# PERMIT

P 524495

## ON-SITE SEWAGE DISPOSAL SYSTEM HOWARD COUNTY HEALTH DEPARTMENT BUREAU OF ENVIRONMENTAL HEALTH

# OCHELTREE RESIDENCE POOL HOUSE

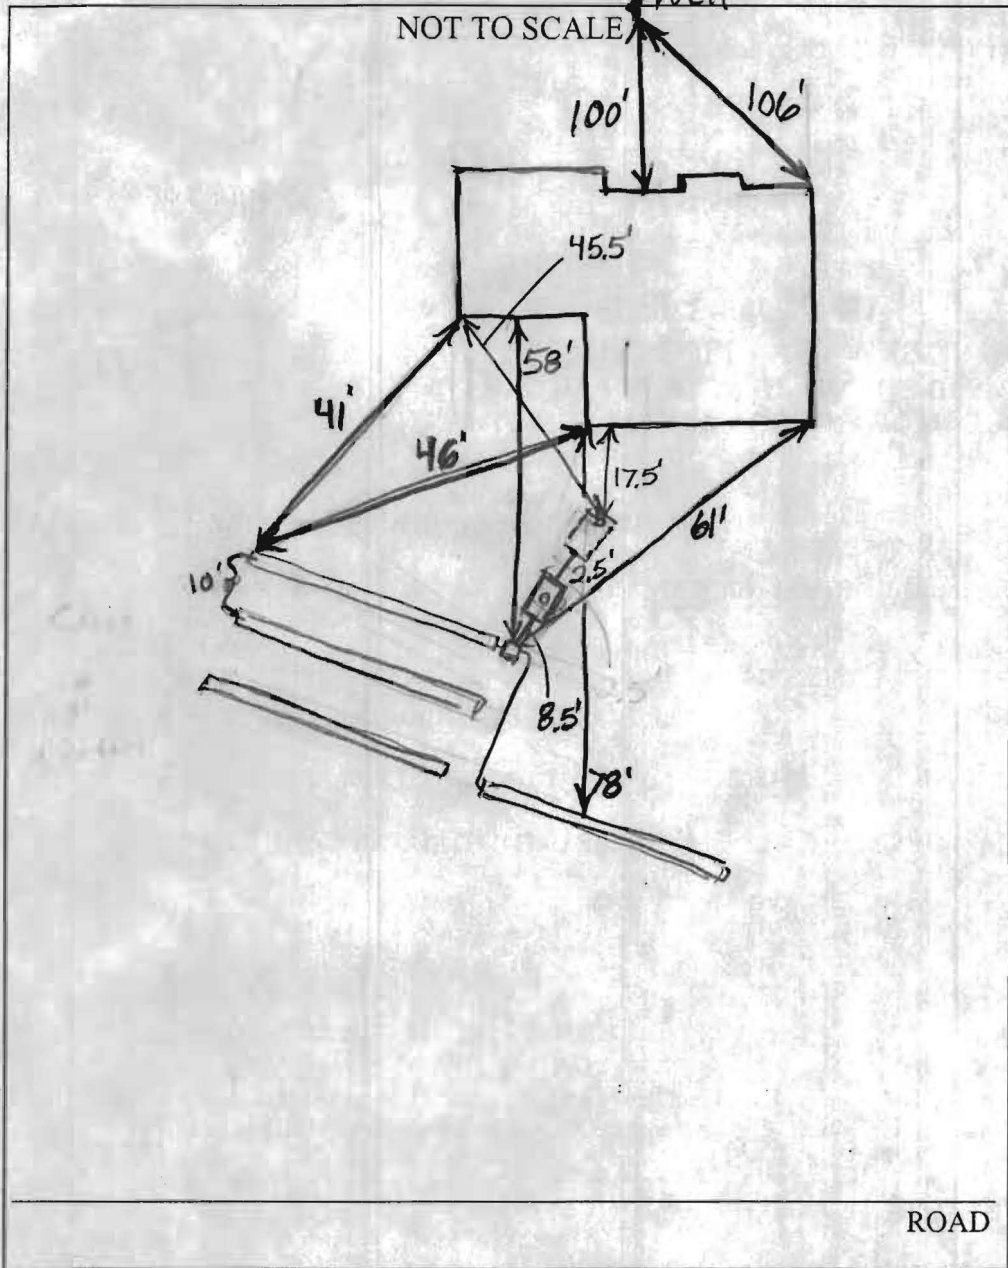
TRENCHES:	Trench to be 2.0 feet wide. Inlet 3.0 feet below original grade. Bottom maximum depth 7.0 feet below original grade. Effective area begins at 3.0 feet below original grade. 4.0 feet of stone below distribution pipe.
LOCATION:	
NOTES:	Four trenches need to be abandoned and 3-4 new trenches are to be added in the new septic field as shown on the approved plan. One original trench can be kept as long as there are no complications with the installation.

INSTALLATION 6/8/06 Additional 500 gallon tank installed after existing tank. Some of the existing trenches were located. Installed trenches have about a 10' center to center separation. Gave installer permission to cover without final inspection. (PB)

SECOND FLOOR PLAN

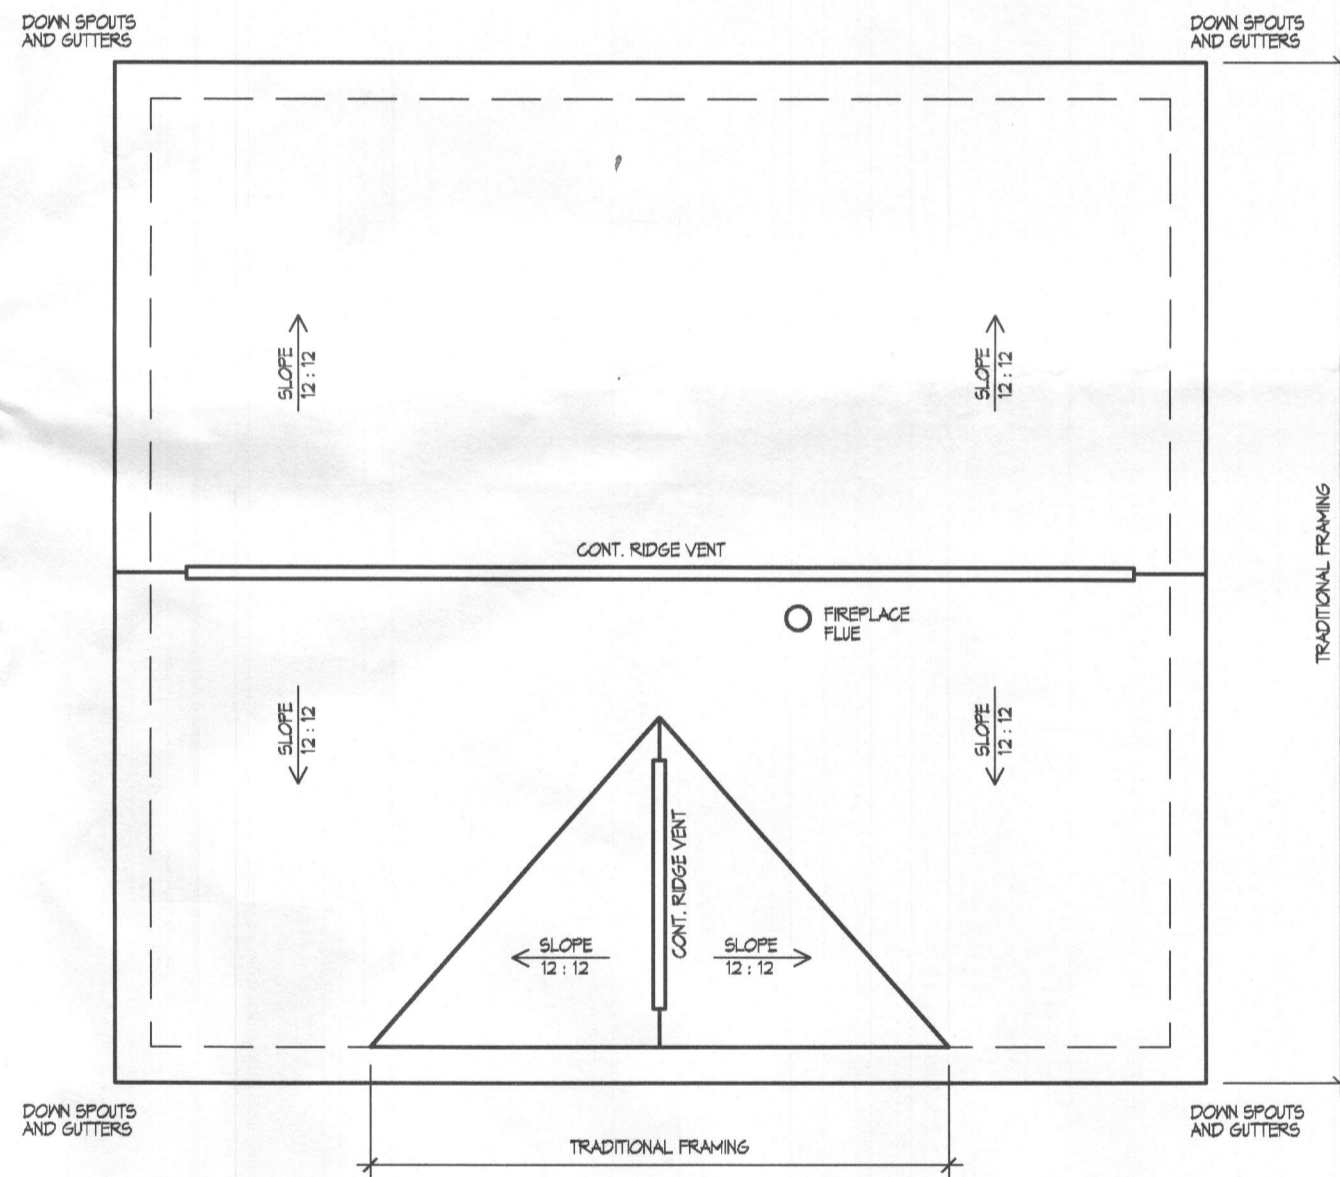
- ① Determine if ex. system is adequate. We will consider the second floor room a bedroom.
- ② Determine if there is adequate area available for two replacement systems, within the existing sewage disposal area. (Second 10,000 not req'd.)
